19 August 2024

Hugo Wind Energy Facility

AQUATIC IMPACT ASSESSMENT ADDENDUM FOR THE HUGO WIND ENERGY FACILITY, WESTERN CAPE

Figure 1: Proposed layout May 2024 in relation to delineated wetlands and watercourses

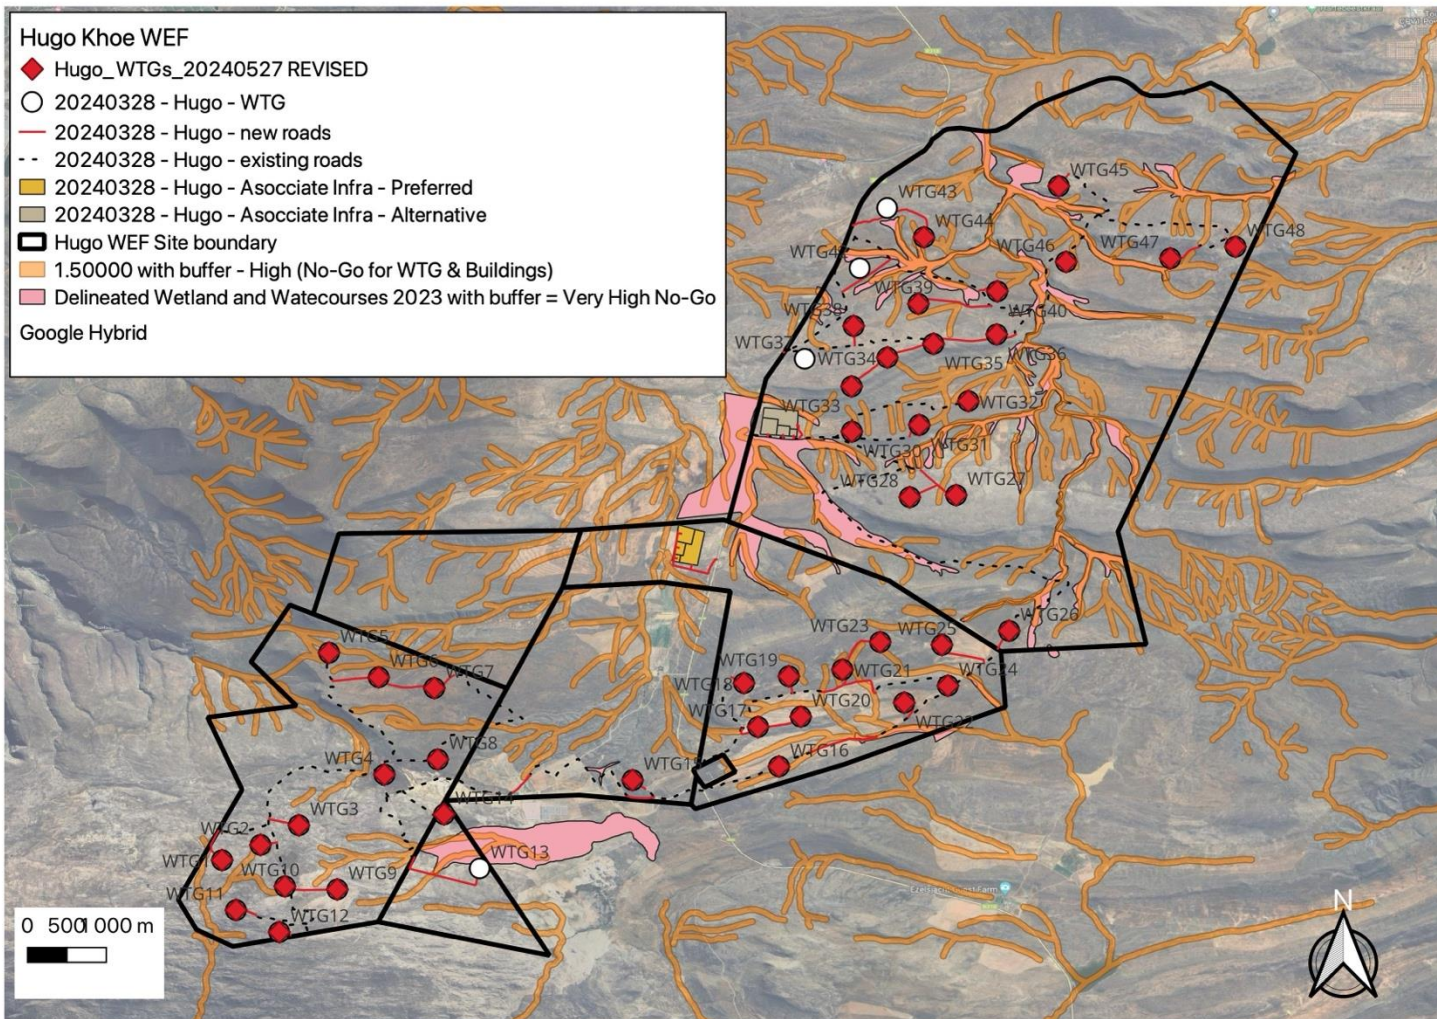
This statement then considers the observed aquatic habitat and coupled to the revised facility layout, as shown in Figure 1 below, where several of the wind turbines have been removed from the development option (white circles) thus resulting in a reduction in the footprint.

To conclude, the initial aquatic assessment findings can be upheld, and when coupled to the proposed layout, with no direct impacts to any critical aquatic ecosystems with a Very High sensitivity are anticipated with regard the WTG positions and alternative building layouts (e.g. O/M Buildings).
